**RE: Town of Kittery, Planning Board Services
35 Badgers Island West Residential Conversion Drainage Review #3
Tax Map 1, Lot 32
CMA #591.156**

**Re: Preliminary Site Plan Review Application; Conversion to Residential
Tax Map 1, Lot 32, 35 Badgers Island West
Response to CMA Comments**

DEMOLITION PLAN **C5**

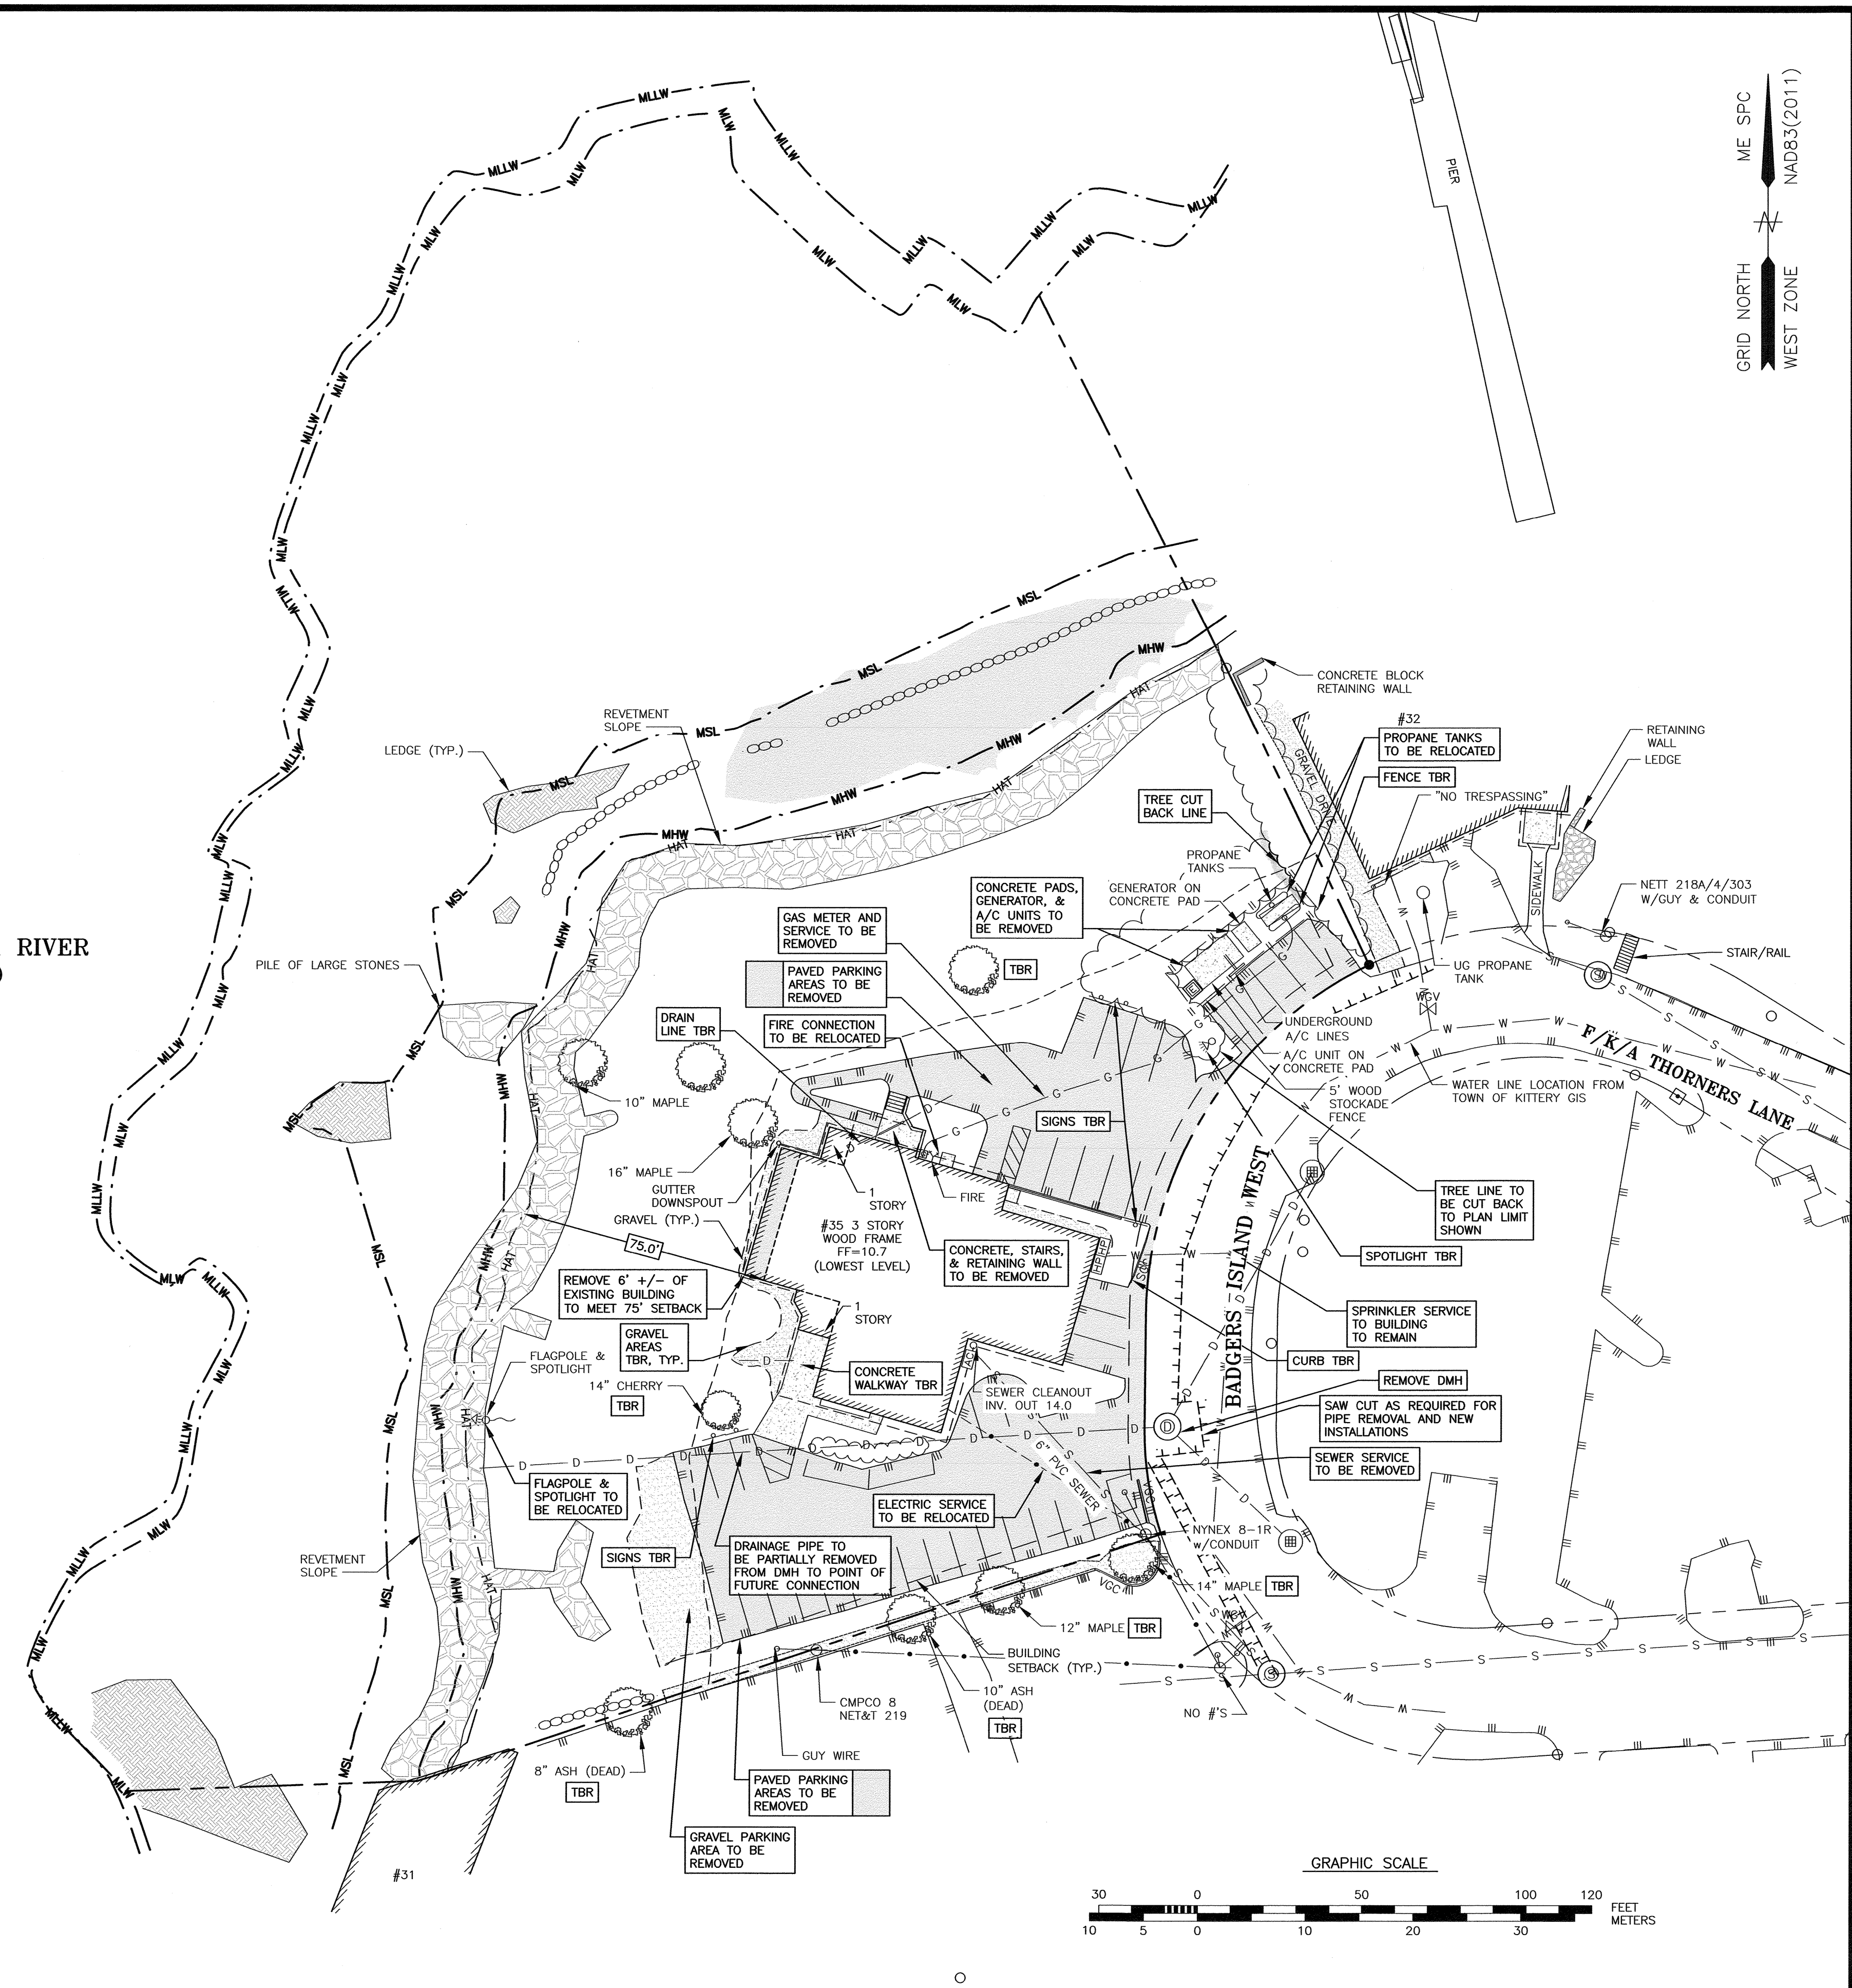
Sheet C5 – Demolition Plan

1. The leader "Tree line to be cut back to landscape plan limits" should be removed or clarified. There is no cutting back of the tree line shown on the landscape plan.
2. Call out DMH #1657 to be removed.

Sheet C5 – Demolition Plan

1. The leader “Tree line to be cut back to landscape plan limits” should be removed or clarified. There is no cutting back of the tree line shown on the landscape plan. **Both the C5 Plan and the L1 Landscape Plan have been clarified.**

2. Call out DMH #1657 to be removed. **Done.**
